# Chatham County, NC

**File #:** 22-4412      **Version:** 1

**Title:** Vote on a request by Ben Mayo, P.E. of Withers Ravenel on behalf of Windjam Development (RBV 1525, LLC) to approve for Subdivision First Plat review and approval of Flatiron Forest, consisting of 29 lots on 42.124 acres, located off Hamlets Chapel Rd (S.R. 1525), Parcel 2037.

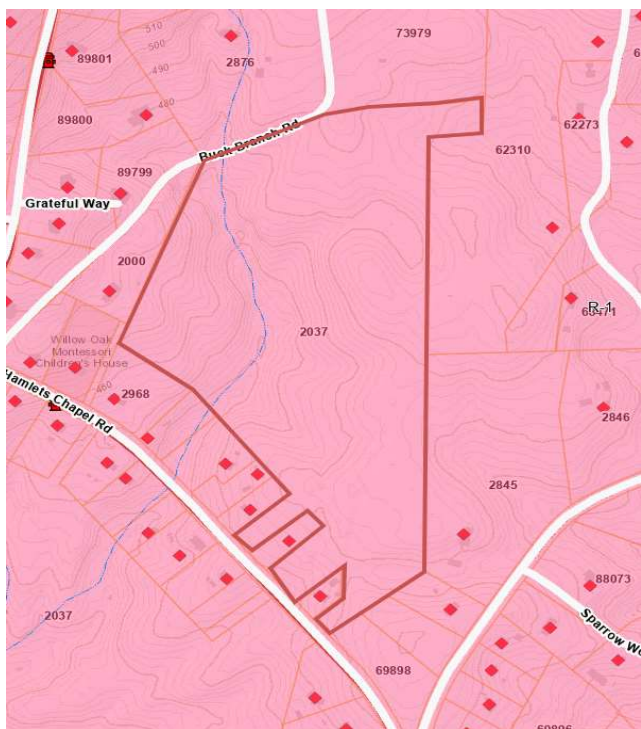
**Septic:** According to Environmental Health septic field layouts will be needed for 1,2,6,7,11,16,22,28, &29 depending on the amount of suitable soils that will be available once the house sites are located. Central Carolina Soil Consulting, PLLC submitted a soil/site evaluation to the applicant on December 11<sup>th</sup>, 2021. The report is attachment 7.
